**Re: Letter Of Notification Of PPL Electric Utilities Corporation, Filed Pursuant To 52 Pa. Code Chapter 57 Subchapter G, For Approval To Rebuild Approximately 0.3 Miles of the Existing Juniata-Cumberland 230 kV and Williams Grove-Cumberland 230 kV Transmission Lines To Re-Terminate Each Existing Transmission Line Into the Expanded Cumberland Substation in Silver Spring Township, Cumberland County, Pennsylvania
Docket No. A-2024-3050132**

**PPL Electric Utilities Corporation
Response to the Set II Data Request of the
Bureau of Technical Utility Services
Dated September 30, 2024
Docket No. A-2024-3050132**

See amended Figure 1-2 below.

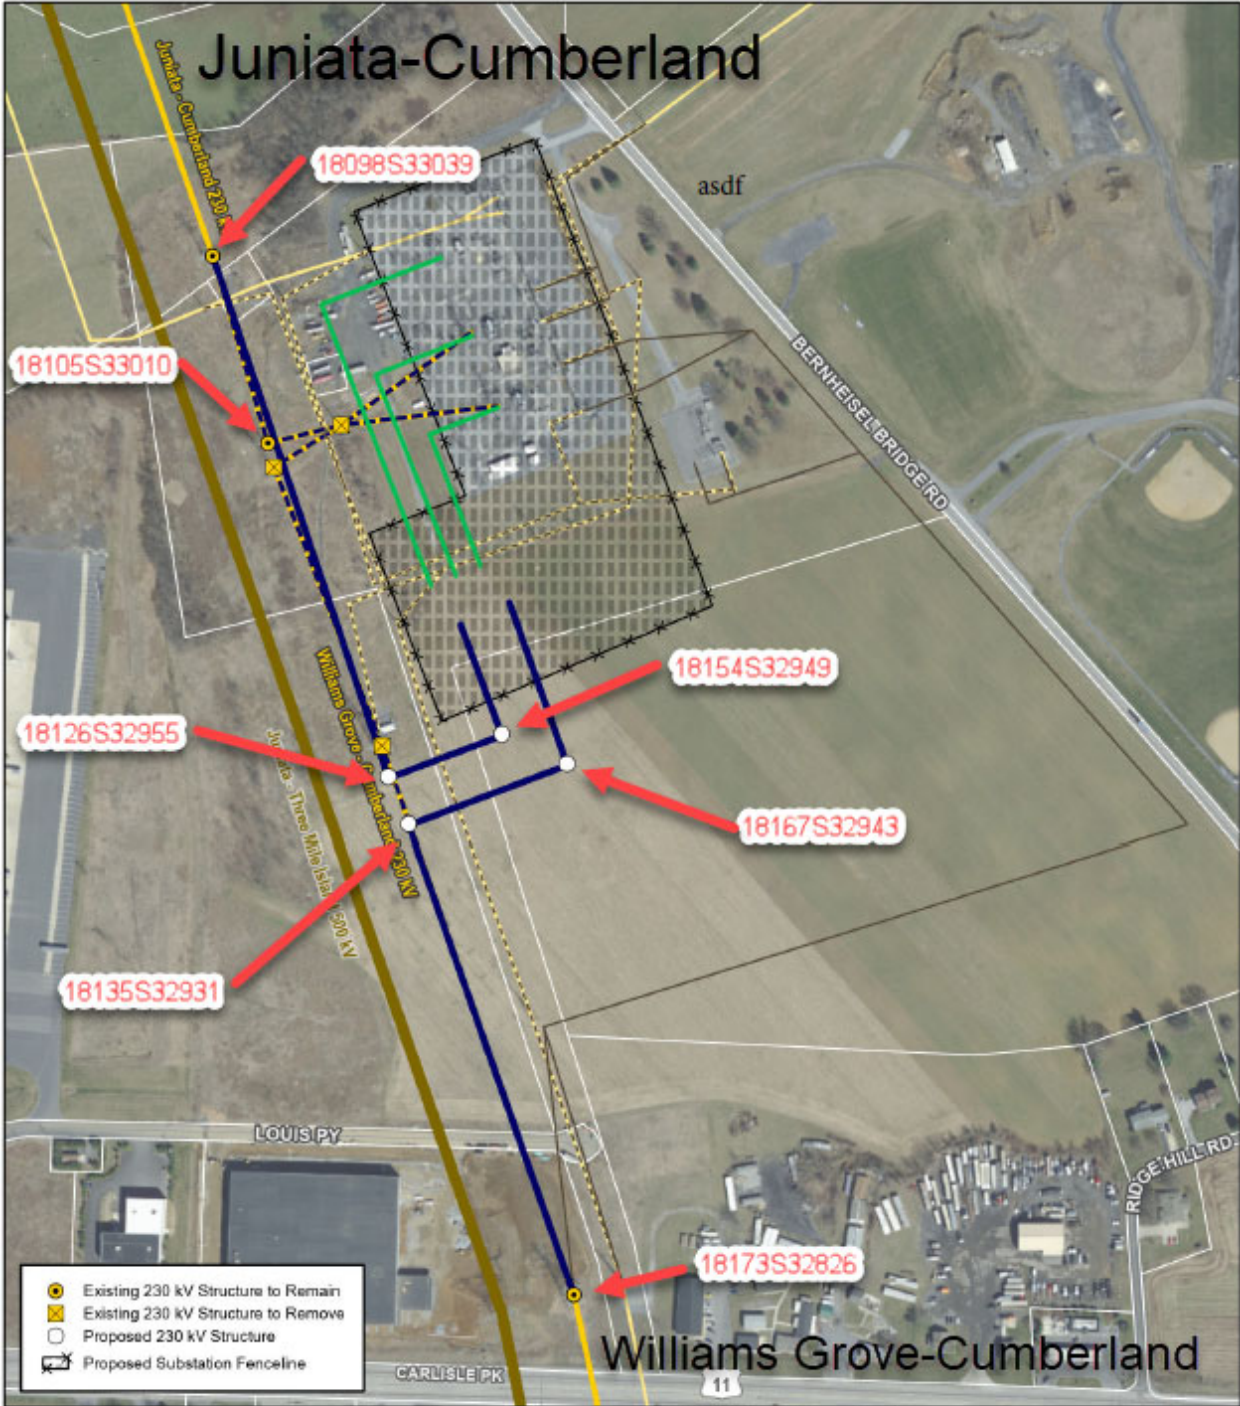
Q. TUS-II-9 Reference the Letter of Notification, Paragraph 27. Please provide a detailed description of the sections of line to be rebuilt including the start and end point with structure IDs.

A. TUS-II-9 The Juniata-Cumberland transmission line will be modified starting at existing structure 18098S33039 (to remain) through existing structure 18105S33010 (to remain) leading southward and connect to the proposed new angle structures 18126S32955 and 18154S32949 and connect to a new 230kV substation bay southwest of the existing substation.

The Williams Grove-Cumberland transmission will be modified starting at existing structure 18173S32826 (to remain) and head northward and connect to the proposed new angle structures 18135S32931 and 18167S32943 and connect to a new 230kV substation bay southwest of the existing substation.
